CLD-A100

SERVICE INFORMATION

No. : SI-V48056

#	REASON FOR CHANGES
1	Addition of seals to the flexible cable
1	To protect the cable from burrs on its cable

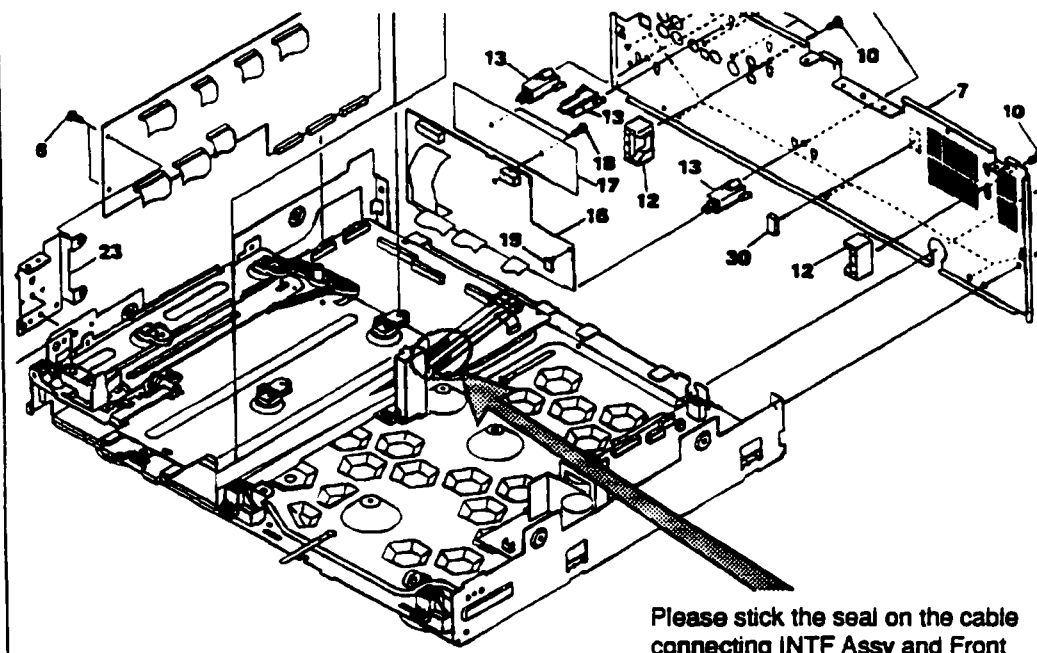
Please stick the seal on the cable connecting INTF Assy and Front Panel near the core holder

Ref.	CURRENT PARTS			CO	NEW PARTS	
	#	SYMBOL/DESCRIPTION	PART NUMBER		DE	PART NUMBER
A	1		Added	-	DEC1363	Seal

FTSB Assy

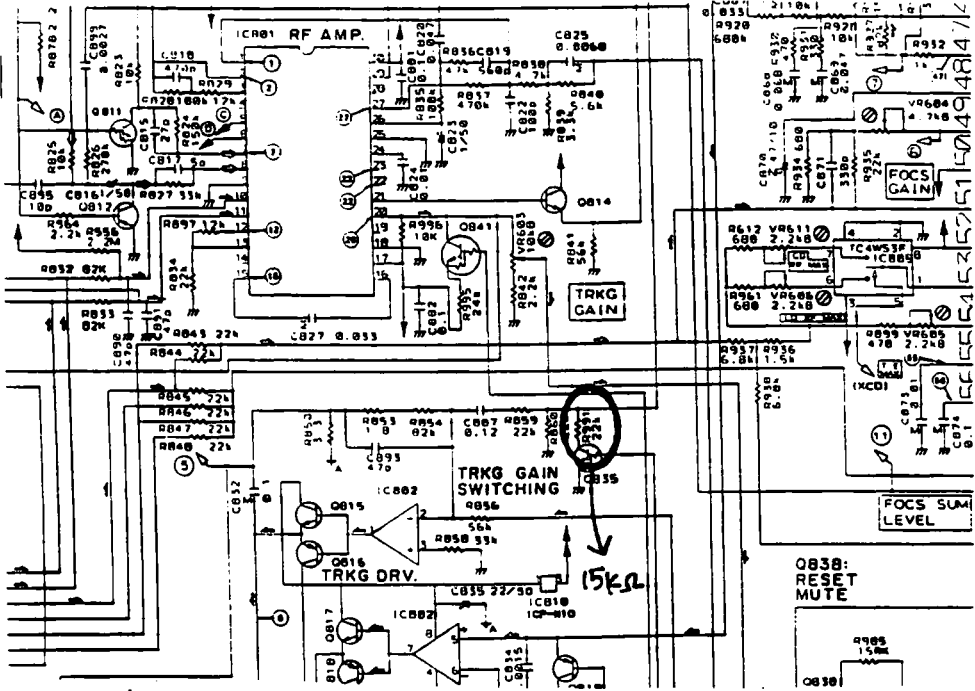
#	DETAIL OF CHANGE(S)	#	REASON FOR CHANGES
1	Change of a resistor in FTSB Assy	1	To improve playability

Ref.	CURRENT PARTS		CO	NEW PARTS	
	#	SYMBOL/DESCRIPTION		DE	PART NUMBER
A	1	R991(22kΩ)	2	RS1/108153J	R991(15kΩ)

[Fig. 1]

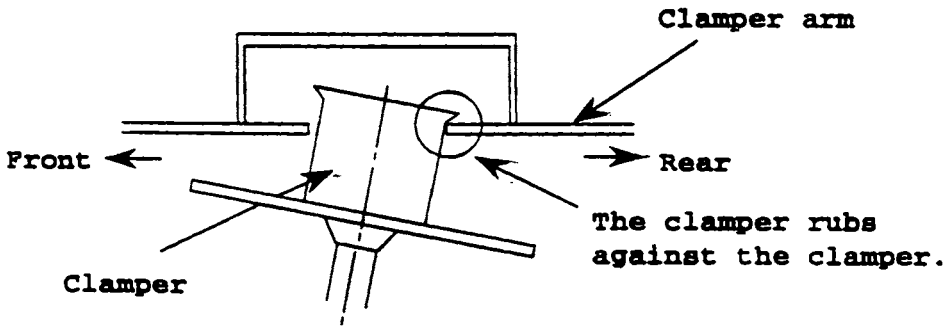
#	DETAIL OF CHANGE(S)	REASON FOR CHANGES
1	Change of the shape of Chassis	X To prevent mechanical noise from being audible when an LD disc is played
2	Change of Rear panel and Front stay, and deletion of spacers

<PROBLEM> Mechanical noise is audible when an LD disc is played.

<CAUSE> When an LD disc is clamped, the motor center axis is slanted due to:

- The height of the mech mounting portions on the Chassis is lower by 0.5mm.
- The mounting position of the mechanism is deviated toward the rear side.

Therefore, the clamber rubs against the clamber arm at the rear side.

Ref.	CURRENT PARTS				NEW PARTS	
	* #	SYMBOL/DESCRIPTION	PART NUMBER	CODE	PART NUMBER	SYMBOL/DESCRIPTION
B 2		Rear panel	(NSP)	-	DN1135	Rear panel
B 2		Front stay	DNE1207	-	(Unchanged)	Front stay
B 2		Spacer	DEC1743	-	Deleted

[Fig. 2]

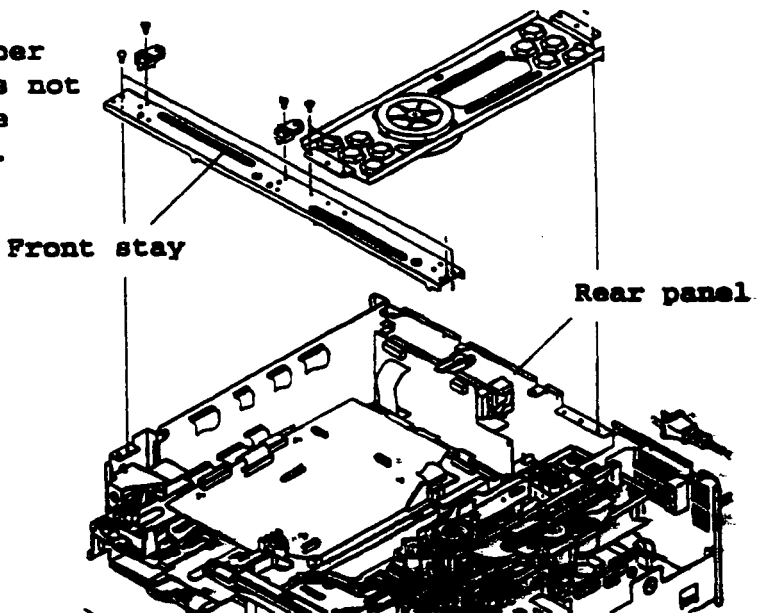
1. Stick 1 or 2 spacers (DEC1743) to the mech mounted portions of the chassis. (See Fig. 2) (One spacer has already been stuck there from the 1st production.)
2. If mechanical noise remains after the spacers are stuck, replace the rear panel and the front stay with the new parts (DNA1135 & DNE1207).

Stick one or two spacers (DEC1743) to these portions.

- 1) Improved the shape of the chassis.
- 2) Changed Rear panel and Front stay, and deleted spacers from the chassis.

Rear panel:	N.S.P.	----	DNA1135
Front stay:	DNE1207	----	DNE1207*
Spacers (x4):	DEC1743	----	Deleted

FIG.3:VIDEO ASS'Y-PARTS MOUNTED SIDE

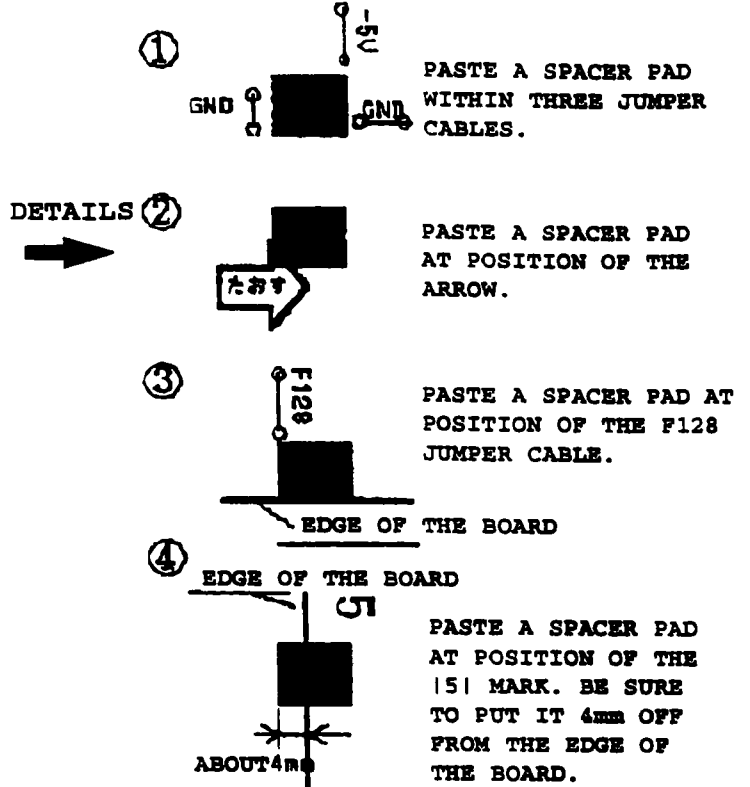
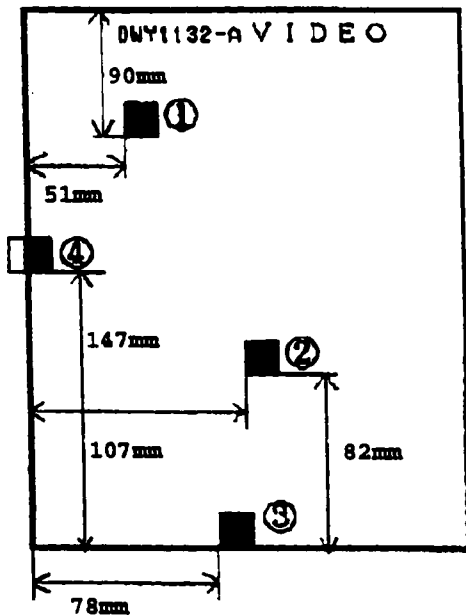
#	DETAIL OF CHANGE(S)	REASON FOR CHANGES
1	ADDITION OF SPACER PADS ON VIDEO ASS'Y	X TO PREVENT THE 12 INCH DISC FROM BEING SCRATCHED

<PROBLEM> THE 12 INCH DISC GETS SCRATCHED WITH A CIRCULAR MARK.
 <CAUSE> DUE TO CLOSE DISTANCE BETWEEN THE DISC AND VIDEO ASS'Y IN THE DISC CLAMPED STATUS, PARTS (CAPACITORS, ETC.) MOUNTED ON VIDEO ASS'Y CONTACT WITH THE DISC WHEN A SHOCK IS APPLIED TO THE UNIT DURING PLAYBACK, CAUSING A CIRCULAR SCRATCH ON THE DISC.

<SERVICE REMEDY> PLEASE ADD FOUR SPACER PADS ON THE PARTS MOUNTED SIDE OF VIDEO ASS'Y TO PREVENT A SIGNAL RECORDED AREA OF THE DISC FROM BEING SCRATCHED WITH A PROTECTIVE CONTACT OF THE DISC EDGE WITH THE SPACER PADS.

*NOTE (1) PLEASE LOCATE A SPACER PAD WITHIN $\pm 1.0\text{mm}$ IN TOLERANCE.

(2) AFTER PASTING A SPACER PAD ON THE BOARD, PLEASE APPLY THE SILICONE ADHESIVE (GYL-1002) AT TWO POSITIONS OF THE PAD AS SHOWN RIGHT. ALSO, PLEASE ASSEMBLE BOARDS INTO THE UNIT AFTER THE ADHESIVE GETS DRY.

[FIG.1: AUDIO MIX CIRCUIT OF SSUB ASSY]

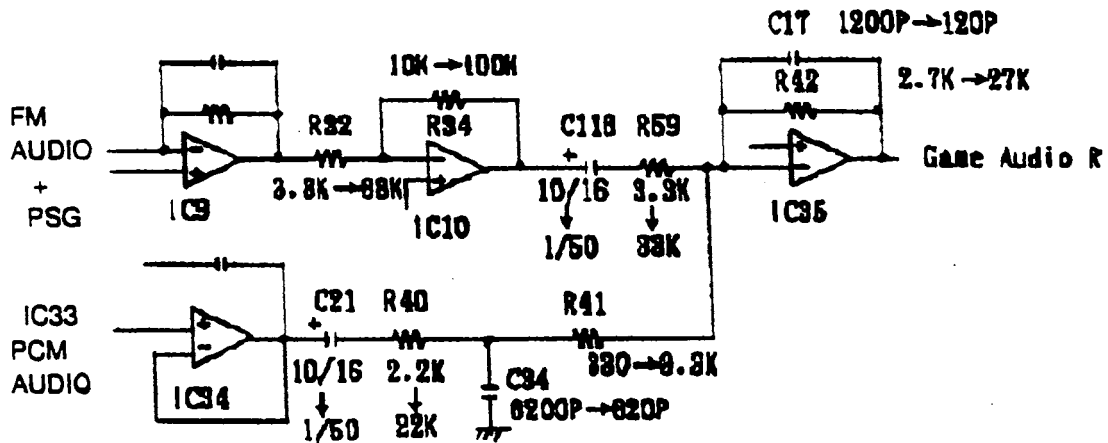
#	DETAIL OF CHANGE(S)	X	REASON FOR CHANGES
1	CHANGE OF AUDIO MIX CIRCUIT	X	TO PREVENT HIGH FREQUENCY AUDIO OF GAME SOFTWARE FROM BEING DISTORTED

<CAUSE> IN CASE THE RECORDING LEVEL OF A SEGA GAME SOFTWARE IS HIGH IN AUDIO, AUDIO OUTPUT FROM OP-AMP (SSUB ASSY:IC10) IS DISTORTED DUE TO HIGH CURRENT OPERATION OF THE AUDIO MIX CIRCUIT.

PLEASE MODIFY THE AUDIO MIX CIRCUIT AS SHOWN BELOW.

Ref.	CURRENT PARTS		CO	NEW PARTS	
# #	SYMBOL/DESCRIPTION	PART NUMBER	DE	PART NUMBER	SYMBOL/DESCRIPTION
A 1	R31	RS1/108332J	1	RS1/108333J	R31
A 1	R32	RS1/108332J	1	RS1/108333J	R32
A 1	R58	RS1/108332J	1	RS1/108333J	R58
A 1	R59	RS1/108332J	1	RS1/108333J	R59
A 1	R33	RS1/108103J	1	RS1/108104J	R33
A 1	R34	RS1/108103J	1	RS1/108104J	R34
A 1	R38	RS1/108222J	1	RS1/108223J	R38
A 1	R40	RS1/108222J	1	RS1/108223J	R40
A 1	R39	RS1/108331J	1	RS1/108332J	R39
A 1	R41	RS1/108331J	1	RS1/108332J	R41
A 1	R42	RS1/108272J	1	RS1/108273J	R42
A 1	R131	RS1/108272J	1	RS1/108273J	R131
A 1	C33	CCSQCH822J50	1	CCSQCH821J50	C33
A 1	C34	CCSQCH822J50	1	CCSQCH821J50	C34
A 1	C16	CCSQCH122J50	1	CCSQCH121J50	C16
A 1	C17	CCSQCH122J50	1	CCSQCH121J50	C17
A 1	C117	CEV100M16	1	CEV010M50	C117
A 1	C118	CEV100M16	1	CEV010M50	C118
A 1	C21	CEV100M16	1	CEV010M50	C21
A 1	C140	CEV100M16	1	CEV010M50	C140
